# HISTORIC AND DESIGN REVIEW COMPLIANCE AND TECHNICAL ADVISORY BOARD

**HDRC CASE NO:** 2024-152  
**ADDRESS:** 250 QUENTIN DR  
**LEGAL DESCRIPTION:** NCB 6708 BLK 18 LOT 21  
**ZONING:** R-6, H  
**CITY COUNCIL DIST.:** 7  
**DISTRICT:** Monticello Park Historic District  
**APPLICANT:** Maziyar Entezami/ENTEZAMI MAZIYAR  
**OWNER:** Maziyar Entezami/ENTEZAMI MAZIYAR  
**TYPE OF WORK:** Roof reconstruction and modifications, exterior modifications, fencing  
**APPLICATION RECEIVED:** March 29, 2024  
**60-DAY REVIEW:** May 28, 2024 (Postponed to June 21 and July 19; August 23 – Action Date)  
**CASE MANAGER:** Edward Hall

**Historic and Design Review Commission**  
***Design Review Committee Report***

EXISTING/PROPOSED ELEVATION  
SCALE: 1/4" = 1'-0"

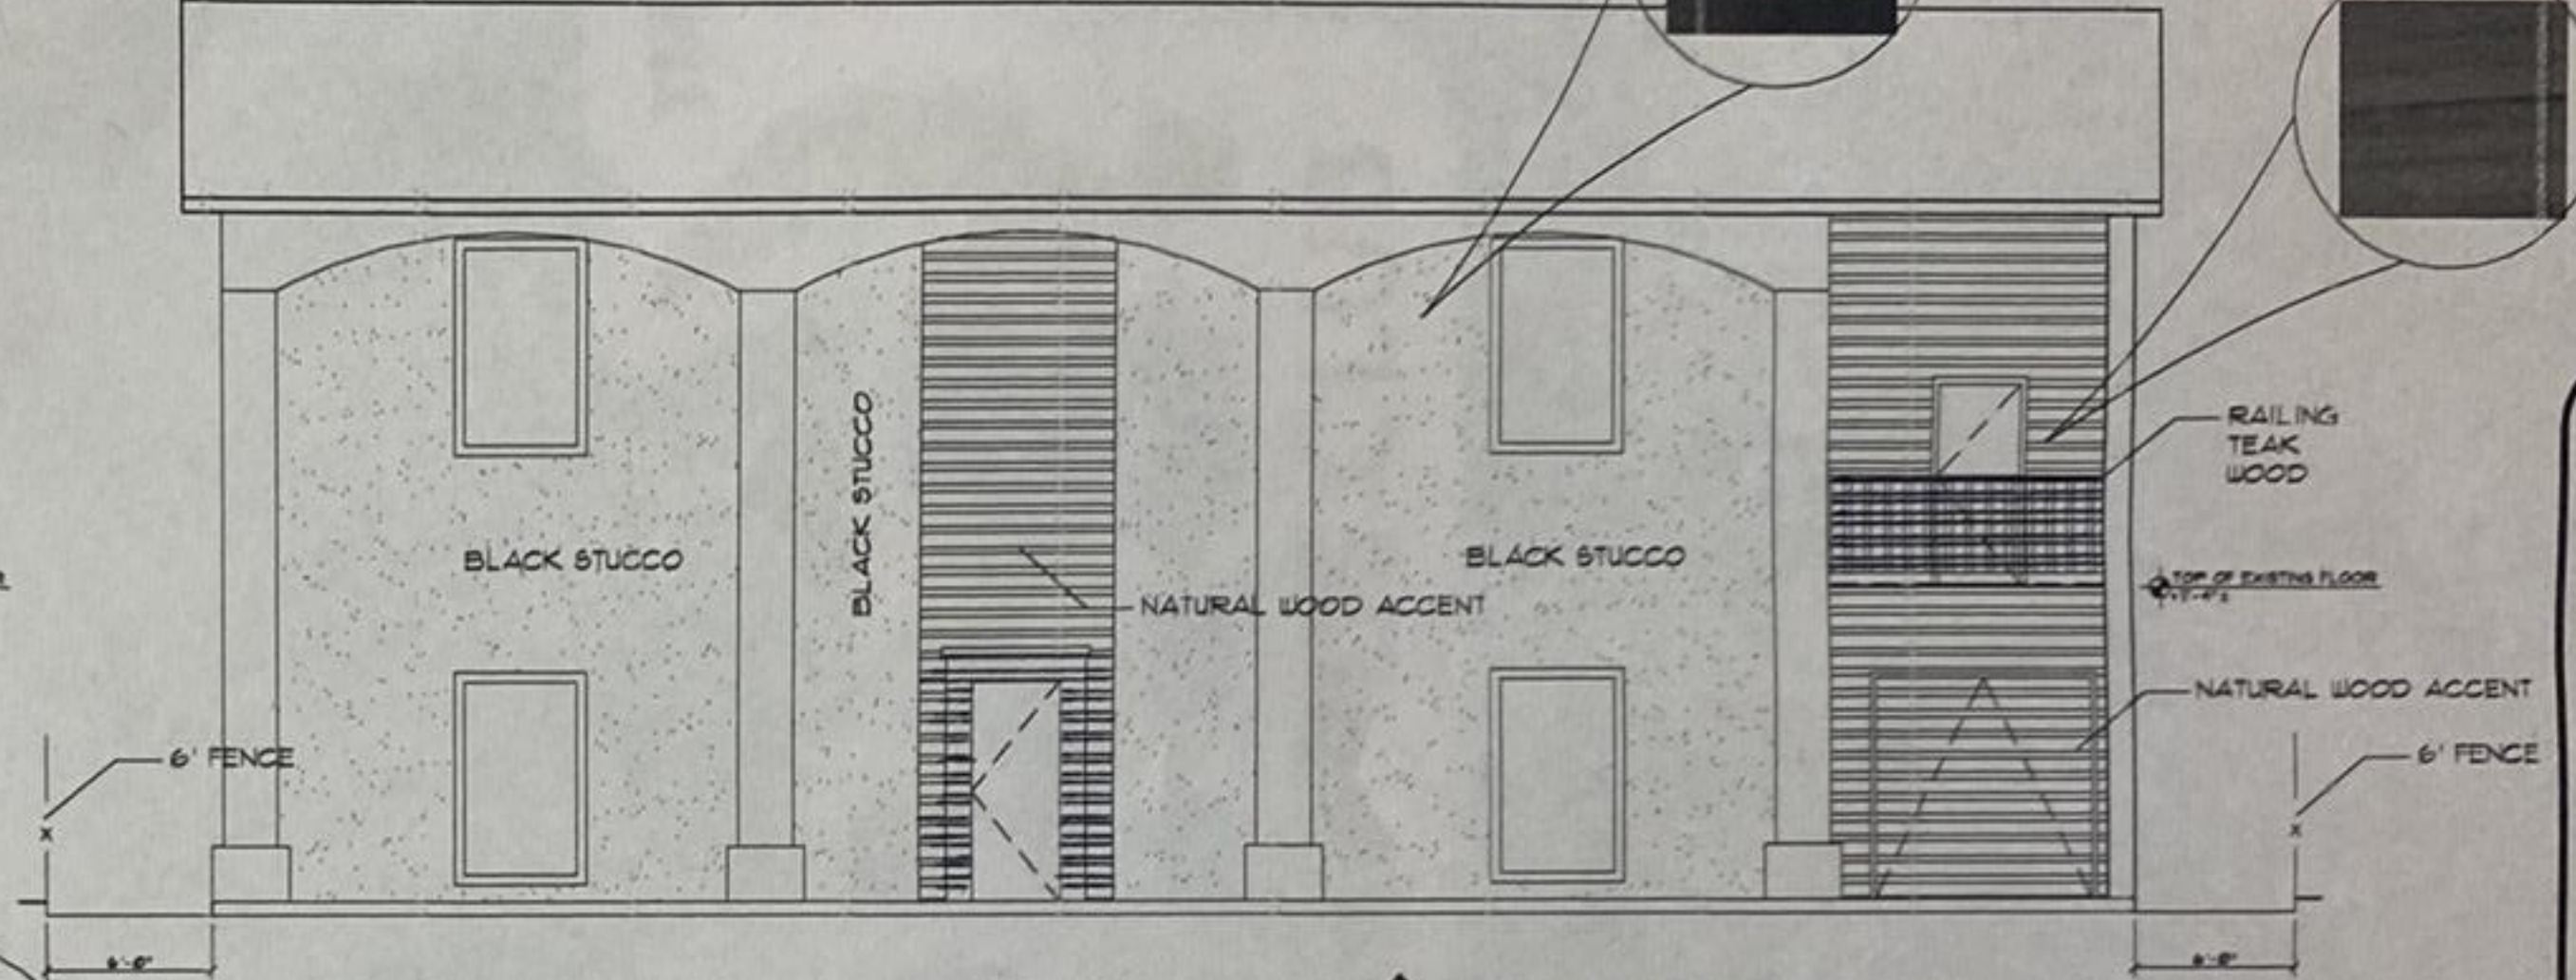
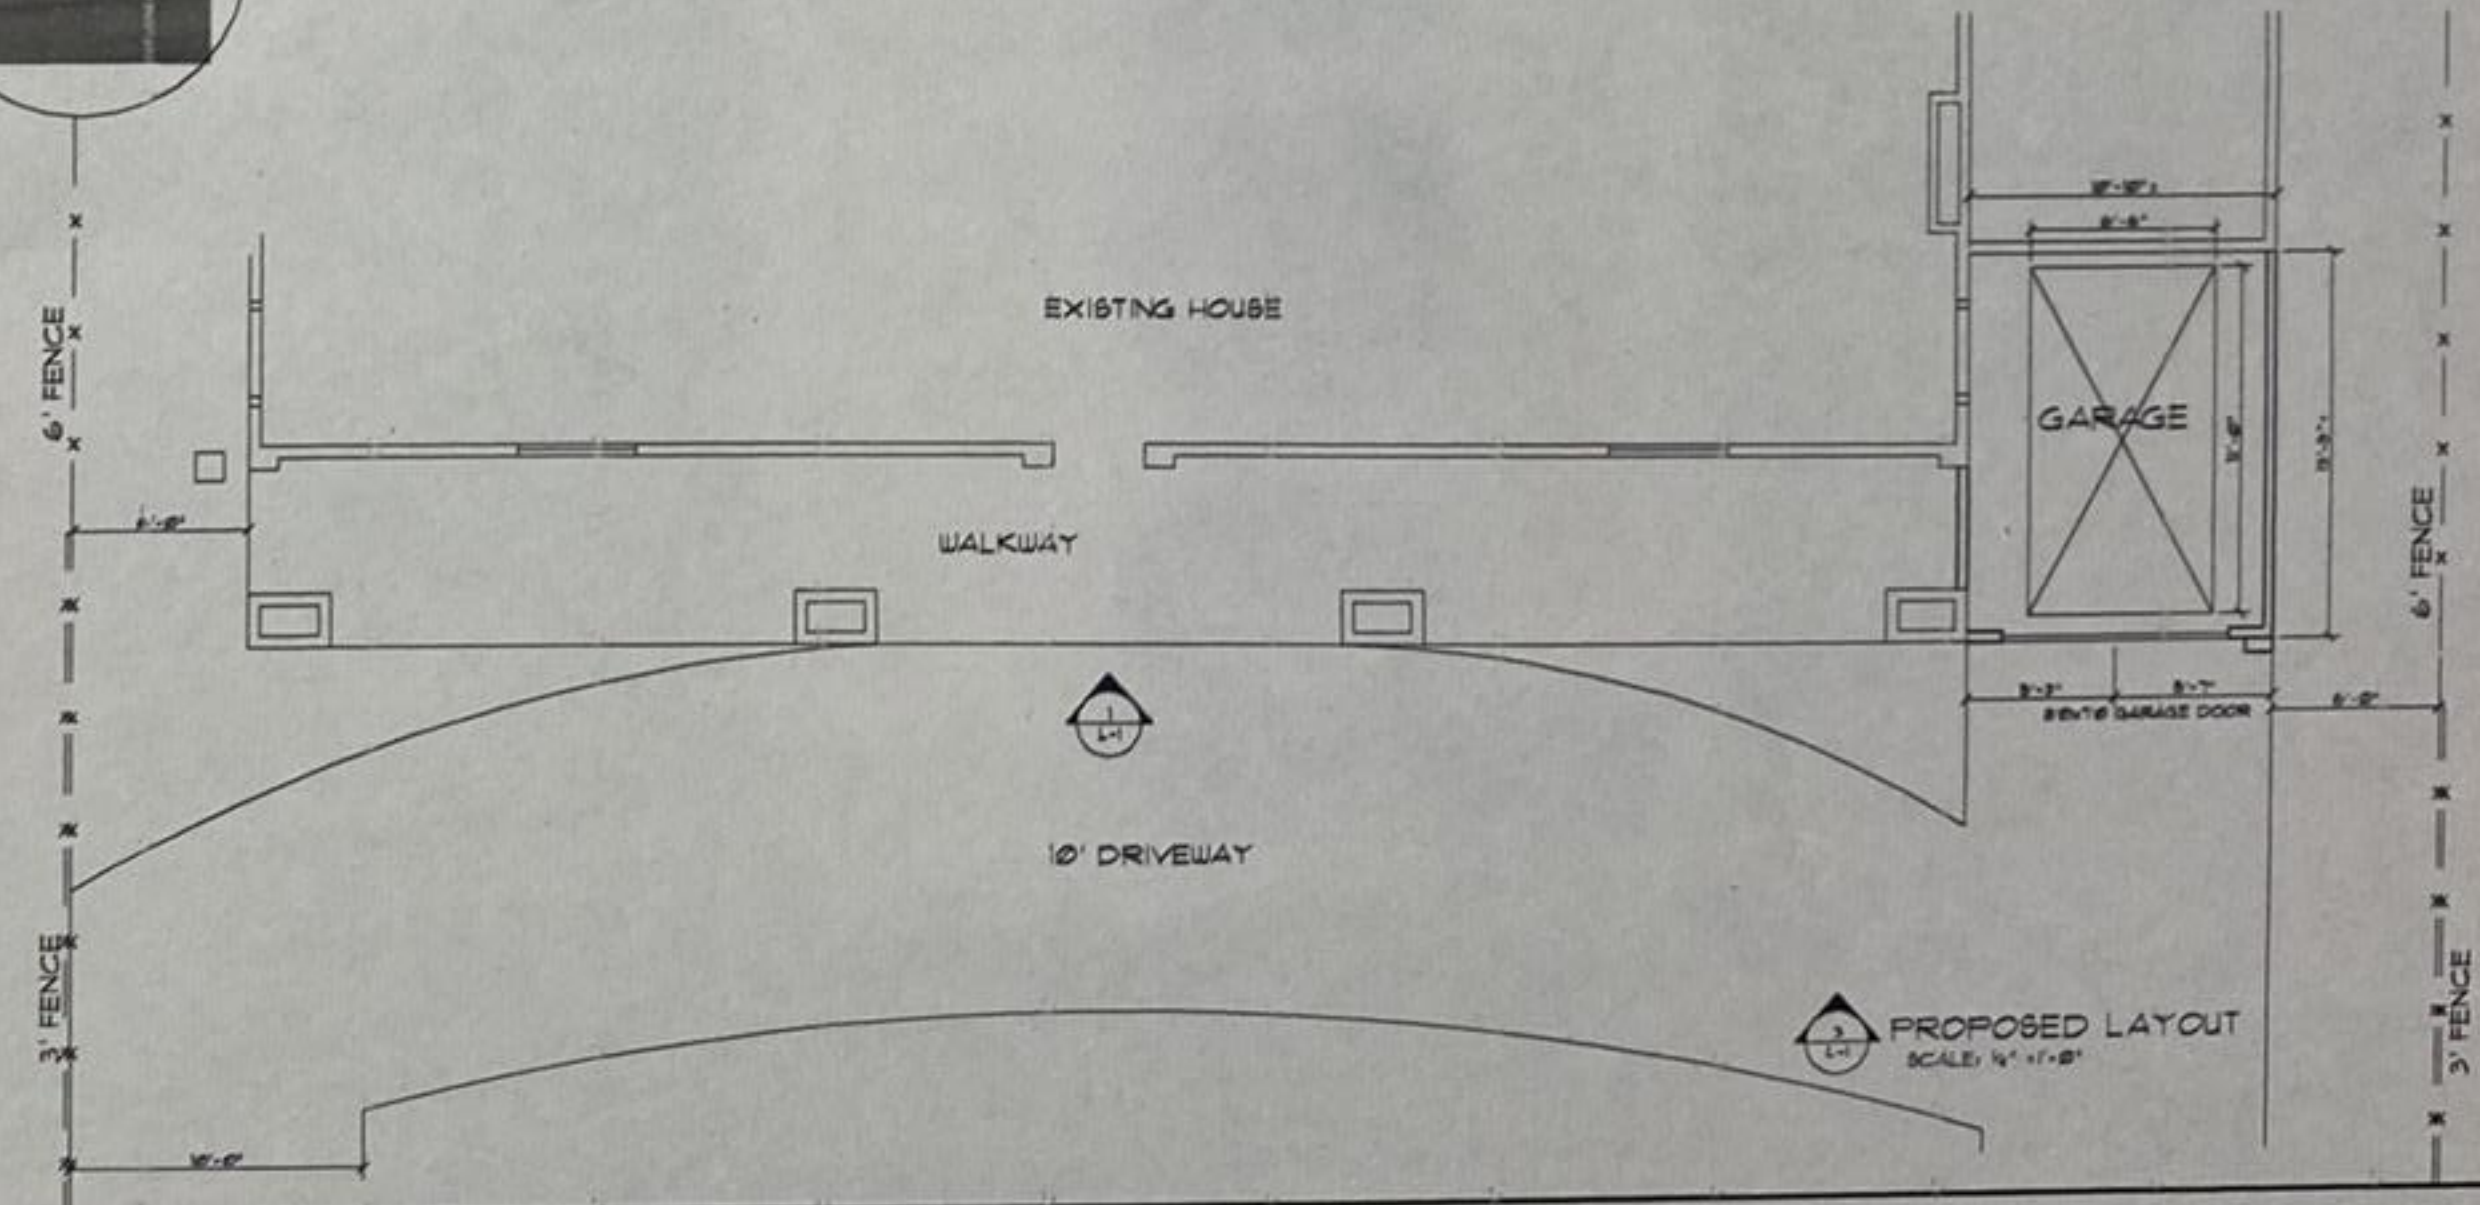
- e. ROOF RECONSTRUCTION – The applicant has proposed to reconstruct the fire damaged roof structure to feature a modified roof pitch and an increased ridge height over an existing side addition. The applicant has not proposed to reconstruct the previously existing chimney. The previously constructed roof featured modifications from the original profile and a modified ridge height. Generally, staff finds the construction of one, centered ridge line to be appropriate; however, staff finds that the side addition should maintain a subordinate ridge height, as was previously constructed. The Guidelines for Additions notes that the roofs of additions should feature subordinate ridge heights.

- g. **FAÇADE MODIFICATIONS (Side Garage)** – The applicant has proposed to modify the façade of the existing, side addition by installing a front facing garage door, a recessed balcony, wood siding and a fifth column. The proposed side addition’s mass will be extended forward to align with the primary façade of the historic structure. The 1941 Sanborn Map notes a garage in the location of the current side addition, where the applicant has proposed to install a garage. Staff finds the proposed request to add a garage door to be appropriate; however, staff does not find the proposal to extend the garage’s footprint forward to be appropriate. Staff finds that the garage’s footprint should remain the same and that the proposed door should feature wood construction or be profiled to appear consistent with those found historically within the Monticello Park Historic District. Staff finds that the façade materials should match the existing on site or that an architecturally and historically appropriate material be proposed for review and approval. Additionally, staff finds that additional construction documents should be submitted to OHP staff for review and approval noting the installation profile and depth of the proposed garage door. Staff does not find the installation of a fifth column to be appropriate.

ME: Reconstructed ridge height matches 236 Quentin

ME: Overview of increase in height of ridge height.

JV: Why the increased height? ME: Per code, two, 5 ton HVAC units are required and 2 water tank heaters will be stored in the attic.

JV & MS: Reconstructed roof is not appropriate and not in context with the existing examples within the district.

MS: By listening to the conversation at the hearing and by looking at previous photos, the roof as reconstructed is not appropriate. An alternative solution with a reduced ridge height should be considered. Additional comments on solutions that could be explored...lower plate heights, dormers, etc.

JV: Ridge height should be decreased.

- 1. Staff recommends approval of item #1, the reconstruction of the roof structure with the following stipulations:
  - i. That the side addition should maintain a subordinate ridge height, as was previously constructed.

- i. That the proposed garage’s footprint remain as it currently exists and not be brought forward.
  - ii. That the façade materials should match the existing on site or that an architecturally and historically appropriate material be proposed for review and approval. The proposed unfinished wood siding is not appropriate.

- iii. That additional construction documents be submitted to OHP staff for review and approval noting the installation profile and depth of the proposed garage door.

- iv. That the proposed fifth column be eliminated.
- 4. Staff does not recommend approval of item #4, fencing, as proposed. Front yard fencing is not found historically on this block of Quentin and is not common within the Monticello Park Historic District. Staff does not find the installation of front yard fencing to be appropriate. Staff recommends approval of privacy fencing, installed behind the front façade of the historic structure. A final site plan noting exact fencing locations is to be submitted to OHP staff for review and approval.
